1419 N TEJON FRONT STEPS AND HANDRAILS REPLACEMENT – REPORT OF ACCEPTABILITY

Historic Preservation Board - June 2, 2025
Staff Report by City Planner: William Gray

An application for a Report of Acceptability to replace wooden front steps with brick steps, and the front steps handrail and decorative curved columns with handrails and columns to match the front porch.

HIST-25-0005

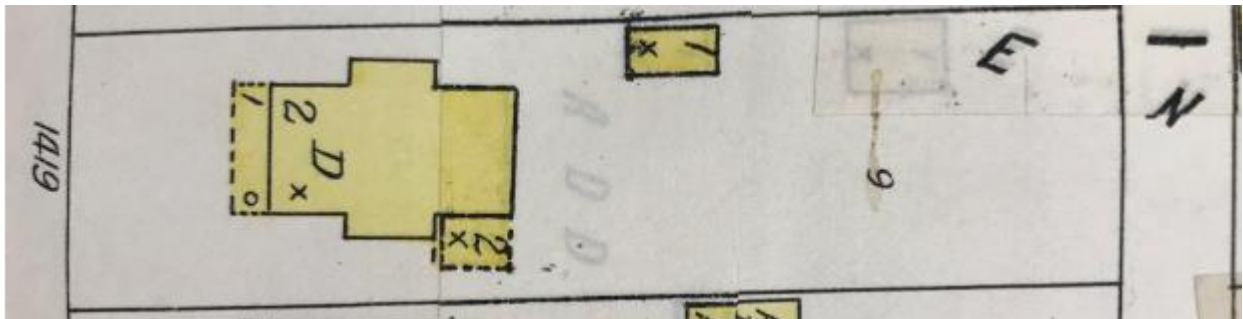
The home is Georgian square in architectural style that has been altered over the years. The images below show how the home has changed over its 130 years of life (from left to right c1896, 1998, 2025). In 1998, the home had a concrete front porch with concrete steps

The change of material with front steps to brick, maintaining the same step height, tread depth, and width of the steps along with changing the existing curved decorative column at the bottom of the step to a half-column to match the existing front porch column at the top of the steps is an appropriate change. The project proposed meets the characteristics of porches in the North End Historic District in terms of location, scale, materials, and quality.
